Review of Need for SESRO following the Gate 3 SESRO Report

31st October 2025

**GARD
Rivendell
142 The Causeway
Steventon
Oxfordshire OX13 6SJ**

Figure 1 – Drivers of demands for more resources in WRSE’s Final Regional Plan

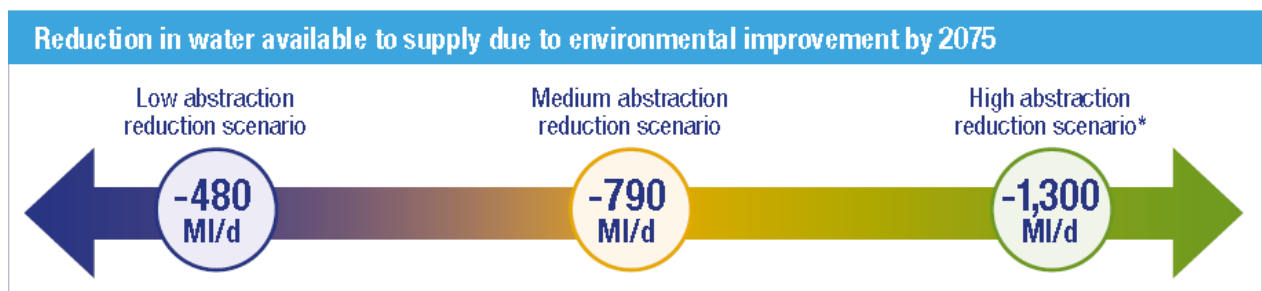
The 1,285 MI/d of abstraction reduction scenario assumed by WRSE and the water companies in their Final Plans is at the upper end of the range of reduction scenarios considered. Much of the reduction would be in areas which would be served by SESRO. The 1,285 MI/d of lost supply is equivalent to nearly five SESROs, with a cost of about £33 billion, based on the Gate 3 SESRO cost of about £6.6 billion.

There was no benefit-cost assessment to justify the new resources needed to replace the 1,285 Ml/d of abstraction reductions in the water companies' Final WRMP24s. Moreover, the EA state in the Government's [Environmental Destination technical report - June 2025](#)⁶

The trebling of the costs of SESRO in the Gate 3 report has made the need for a proper benefit-cost of the abstraction reductions even more urgent.

Figure 2 - Potential range of total population forecasts for Thames Water

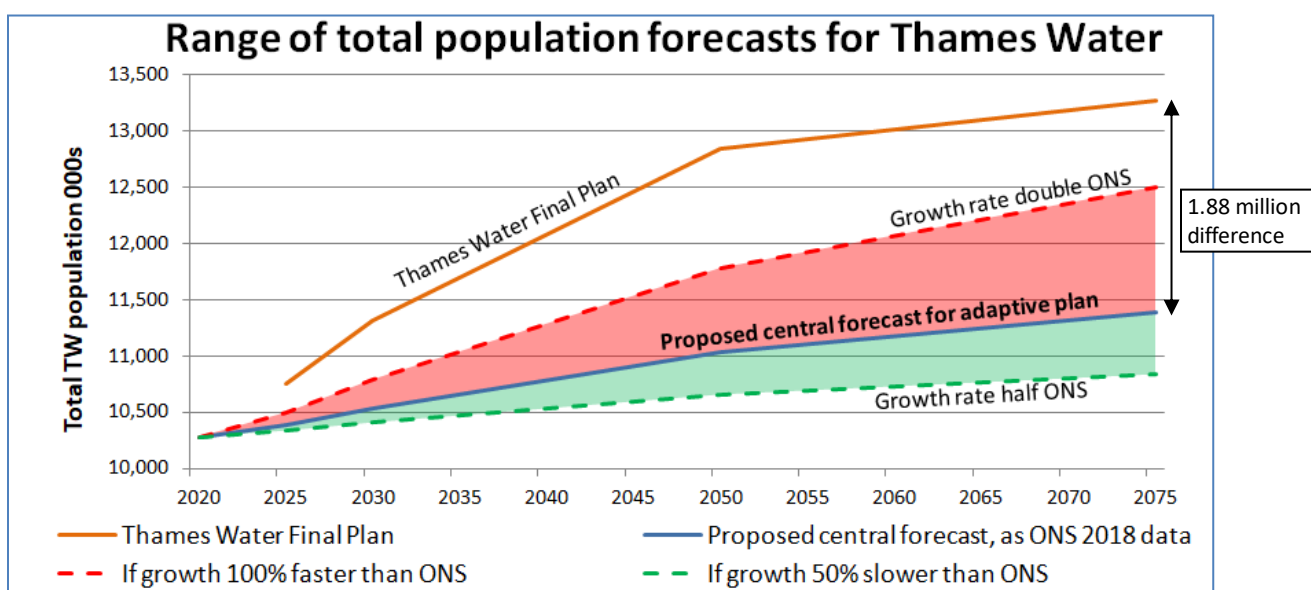
This graph shows the extent by which population forecasts based on local authority planned housing growth would exceed the official ONS forecasts. The 1.88 million population difference in 2075 is equivalent to 225 MI/d of household supply. There is a similar pattern in all Thames Water and Affinity Water’s supply zones potentially served by SESRO, as shown in Table 1 below:

Assuming a per capita consumption of 120 litres per head per day, the total over-forecasting is equivalent to a household demand of 315 MI/d, which is well in excess of Thames Water’s estimated 271 MI/d deployable output of Abingdon reservoir.

Although there is considerable uncertainty in the population forecasts – upwards pressure from immigration and downwards pressure from declining birth rates – in GARD’s opinion, the forecasts used in Thames Water and Affinity Water’s Final Plans greatly exceed the “most likely” future, which the Water Resource Planning Guideline says should be the basis of preferred plans.

Figure 3 - Winter UK rainfall trend since 1840

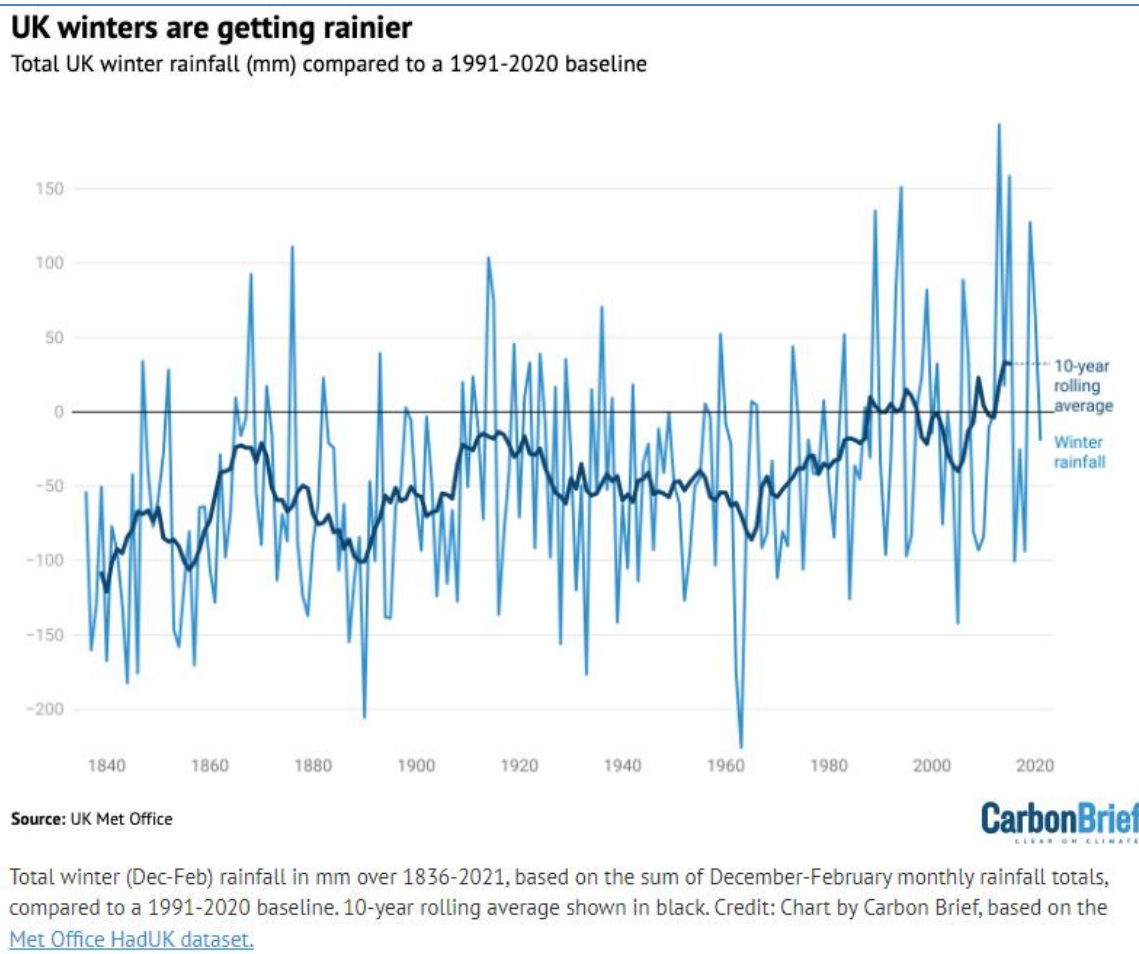
The Carbon Brief report referred to above also notes that 7 of the 10 wettest winters in the UK have occurred in the past 35 years and comments that this makes sense because, as the atmosphere heats up, it is able to hold more moisture, which can then fall as rain. The increasing trend in winter rainfall improves the resilience of London's supplies in the multi-season droughts which govern their deployable output. The winter rain is stored in the chalk aquifer and released slowly through the summer, raising drought flows and reducing the rate of depletion of the London reservoirs.

If the deployable output of London's existing supplies is determined only using the 80 years of river flow records since the 1940s, modelling shows that it increases by more than 200 MI/d, compared with the deployable output assessed using historic records since 1920²².

In GARD's opinion, the realistic range of climate change impact on the deployable output of Thames Water's supplies can lie between a gain of 200 MI/d and the High Impact scenario loss of 186 MI/d. By adopting the High Impact scenario loss in their preferred plan, Thames
